Re: Product Change Notification for Harwin product.

Product in the C90-3106F range has been subject to dimensional changes relating to the supplied rubber bushing.

C90-3420-X

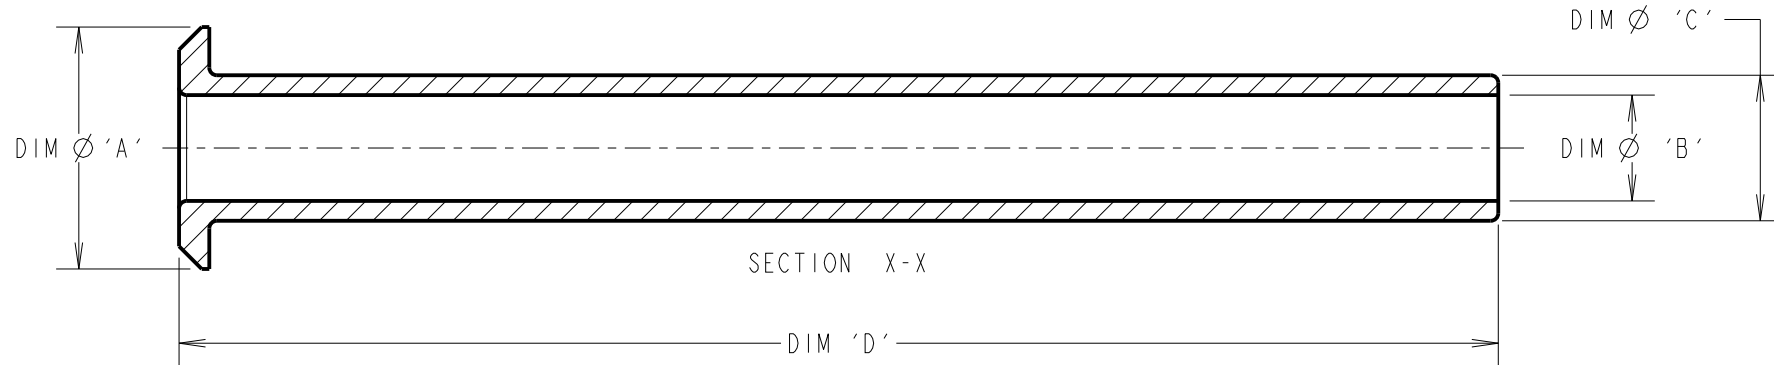
This change was actioned during Q4 2021 – no PCN was triggered or released at this time, so you may have already received stock to the new design. The change was to the size of the inner bore of the bushing.

Inner bore diameter	Supplied Rubber Bushing (also available separately)
Before the change in Q4 2021	6.60mm nominal	C90-3420-5
After the change in Q4 2021	5.60mm nominal	C90-3420-4

If you require the larger bore rubber bushing, please order the C90-3420-5 as a separate component.
